ZONING ORDINANCE

ORDINANCE NUMBER 2016-09

AN ORDINANCE OF THE TOWN OF PARADISE VALLEY,
ARIZONA AMENDING THE PARADISE VALLEY ZONING
ORDINANCE, Article XXII, HILLSIDE DEVELOPMENT
REGULATIONS

RED TEXT IS DRAFT LANGUAGE PRESENTED TO PC AT 12/20/16 MEETING.

FIGURE 2 – HILLSIDE DEVELOPMENT AREA

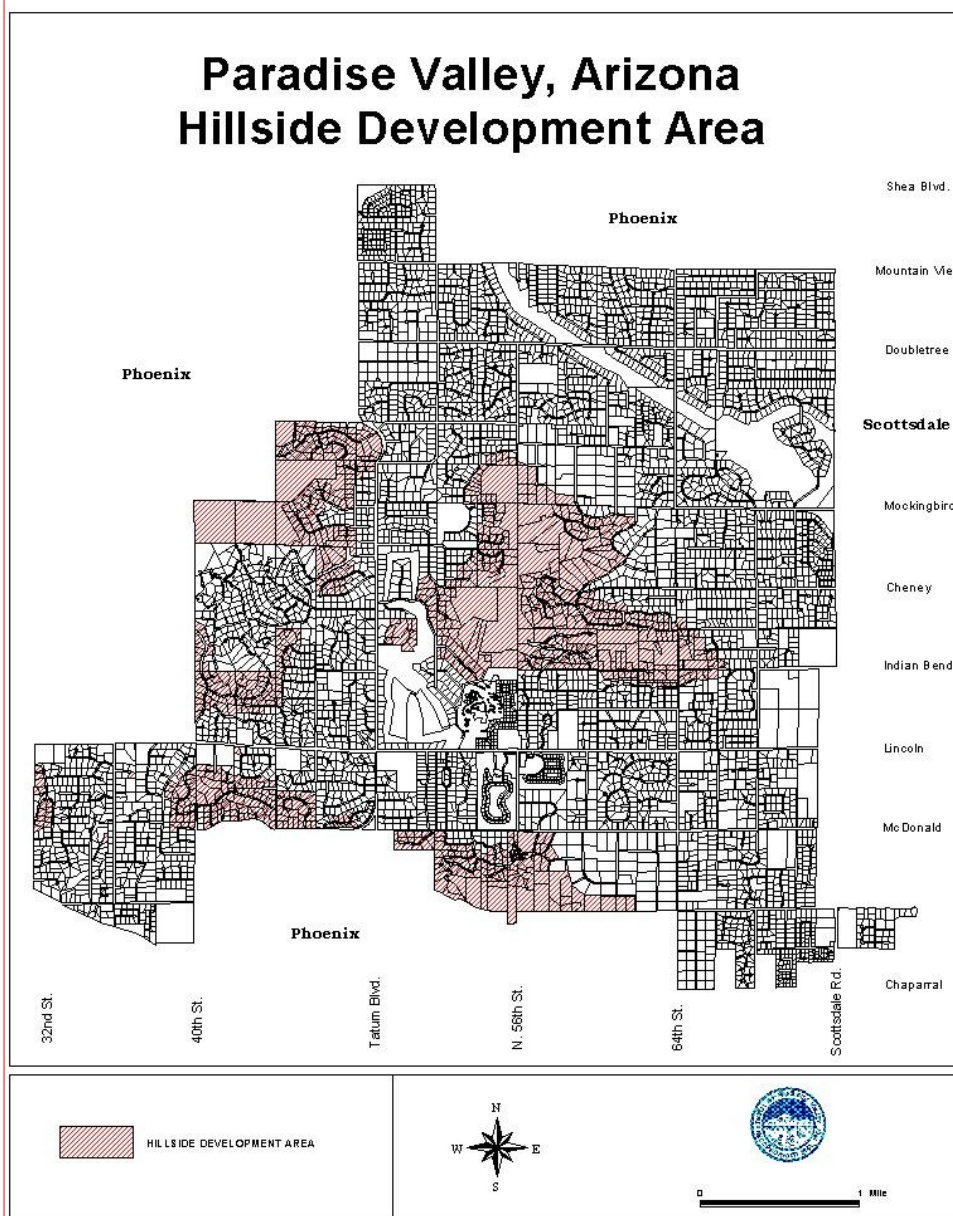
Comment [GB2]: Identify Process to Update Map with any properties removed from Hillside or added to Hillside

FIGURE 5 – BUILDING HEIGHT IN HILLSIDE

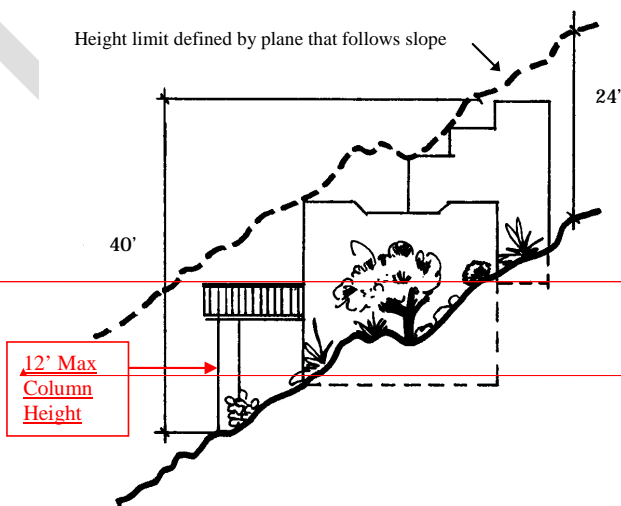
Comment [GB13]: Figure 5 to be updated to reflect these edits.

Comment [GB14]: Update Figure 5 to clarify measurement of 40' maximum height limit.

iii. 3. The maximum overall height of the building or structure, including chimneys and accessory buildings, shall not exceed forty (40) feet from the highest point of the building to natural grade at the lowest point adjacent to the building structure or column of a building or structure to the lowest point of Natural Grade at the lowest building or structure (excluding driveway retaining walls) --(see FIGURE 5).

FIGURE 7 - HEIGHT FOR A CANTILEVERED ELEMENT

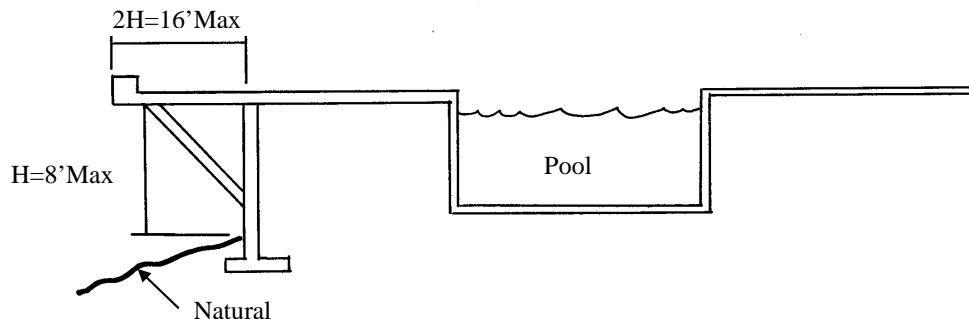
Comment [GB19]: Remove support from illustration on Figure 7.

B- Structures employing the use of a cantilever may extend the cantilever a horizontal distance twice the height of the support. The maximum vertical height of the support shall be eight (8) feet. One half the area underneath the cantilevered element shall be calculated as disturbed area. (See FIGURE 7 below).

FIGURE 8 –TERRACED VERTICAL RETAINING WALLS

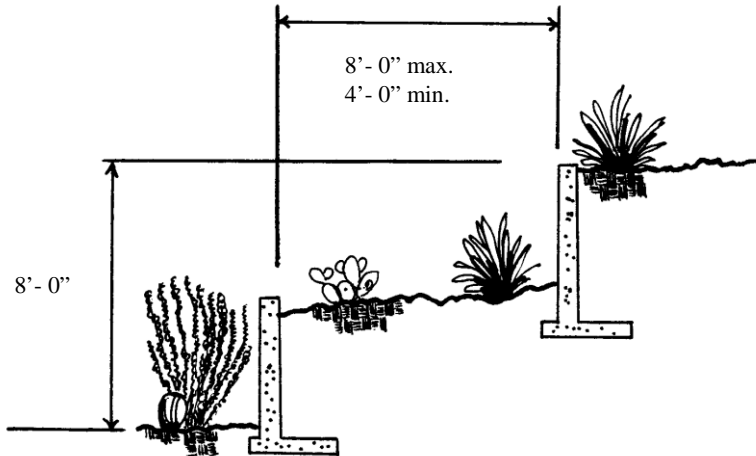
Comment [GB32]: Relocate Figure 8 below the text of 2207.VI.1.e.

- e.e. A terraced combination of retaining walls shall be measured as a single retaining wall provided the combined walls are: 1) no more than eight (8) feet total vertical height; 2) terraced with a minimum distance between of four (4) feet and a maximum separation of eight (8) feet; and 3) contain appropriate vegetation between the walls so as to soften the visual impact of the combined walls (see **FIGURE 8**). These separation requirements apply to any single lot and do not apply to adjoining walls on neighboring properties.
